Development Application **ACCESS REPORT**

Reference Number: 22072

Site Address: 21 - 23 Ellis Street, Condell Park, NSW

This Access Compliance Report is to accompany a Development Application (DA) for the development proposed at **21 - 23 Ellis Street, Condell Park, NSW**

[Image description: Plan of Ground level above shows the provision of Accessible parking spaces]

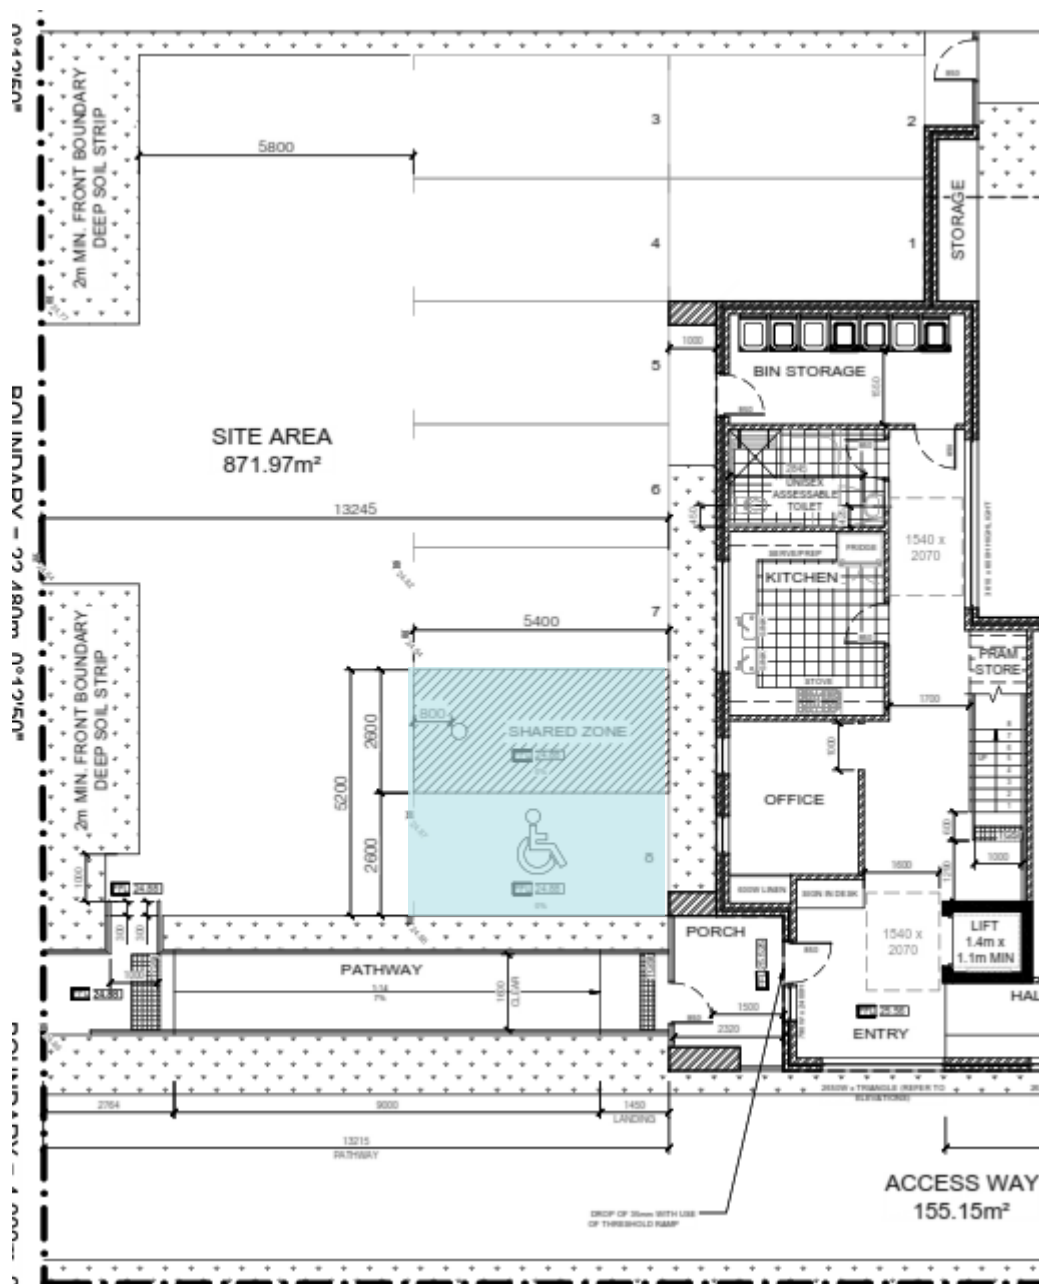
Total number of Accessible parking spaces required / provided in the development = 1.

Ground floor plan

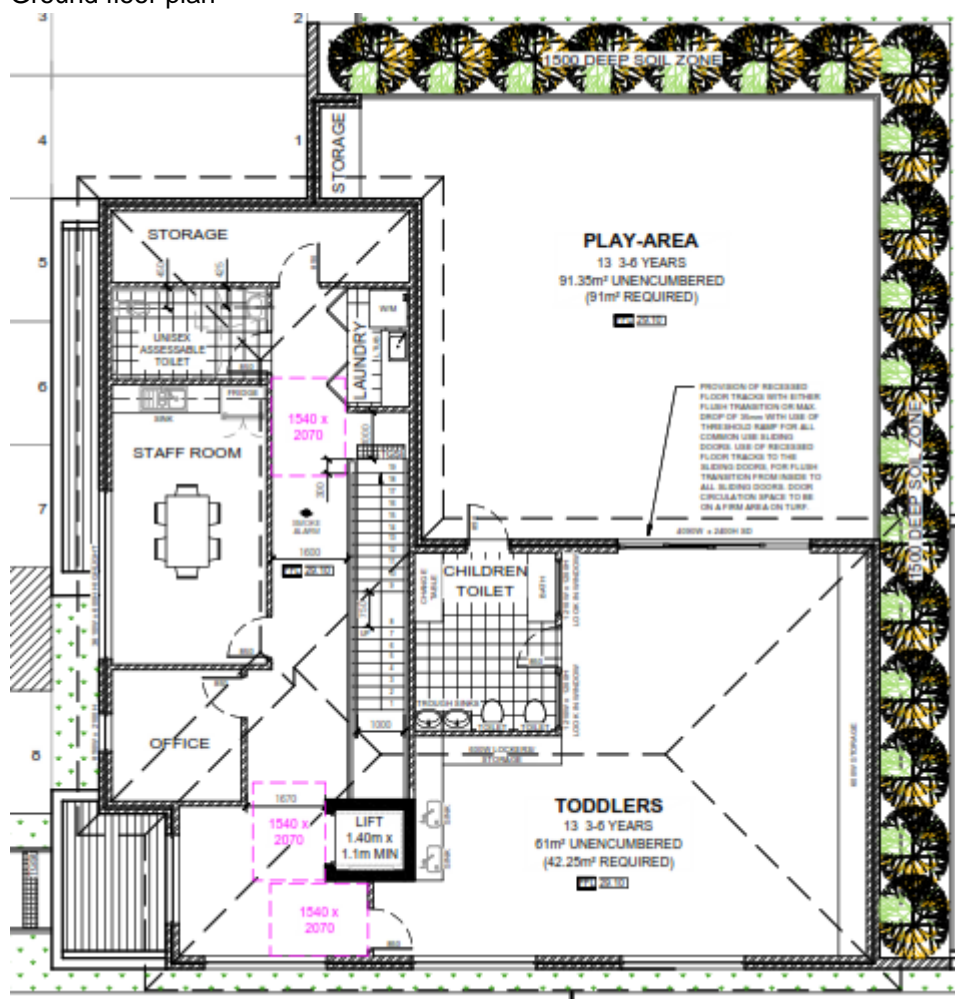
2 unisex accessible toilets have been provided in the development

1 unisex accessible toilet with shower has been provided in the development
